UNITED STATES PATENT AND TRADEMARK OFFICE

10/635,694

Office Action Summary

DETAILED ACTION

FIG. 6

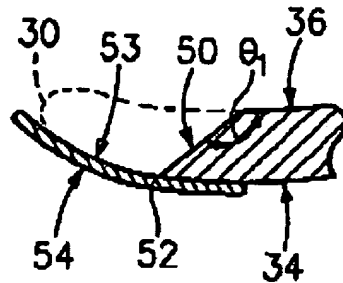
In claim 22, the limitation "the applying places a first portion of the first face along the component" is vague and ambiguous, since it is unclear as to which area of the component the first portion should be applied.

Perhaps this limitation should read, "the applying places a first portion of the first face along [the] a remaining intact leading surface of the component." See Specification at [0022] ("[T]he backing element 52 may be a metallic (e.g., aluminum) tape having first and second surfaces 53 and 54, a trailing portion of the first surface 53 being secured to a remaining intact leading portion of the suction side surface 34.").

Also, claim 22 is incomplete for omitting essential structural cooperative relationships of elements, such omission amounting to a gap between the necessary structural connections. See MPEP § 2172.01. The omitted structural cooperative relationships are: the relationship between the "second portion of said first face" to the first portion of said first face of the backing element and/or component. Perhaps this limitation should read "second of said first face protruding beyond a lost leading edge of

the intact leading surface. See Specification at [0022] ("A forward portion of the surface 53 protrudes beyond the lost leading edge and an intermediate portion extends aligned with a lost portion of the surface 34 along the original contour of the airfoil.")

7. Claim 22 would be allowable if rewritten to overcome the rejection(s) under 35 U.S.C. 112, 2nd paragraph, set forth in this Office action and to include all of the limitations of the base claim and any intervening claims.

8. The following is a statement of reasons for the indication of allowable subject matter: the prior art of record of record does not teach or suggest: a method of restoring a Ti alloy turbine component which has lost first material from a damage site comprising:

applying a backing element to the component adjacent the damage site so that the deposited Ti based material builds up on the component and the backing element; and physically depositing a Ti-based material at least partially in place of the first material, wherein

the backing element has a first face;

the applying place a first portion of the first face along [the] a remaining intact leading surface of the component; and

the physically deposition deposits said Ti-based material along a second portion of said first face protruding beyond a lost leading edge of the intact leading surface,

in combination with the other claimed subject matter. See Figure 6, below.
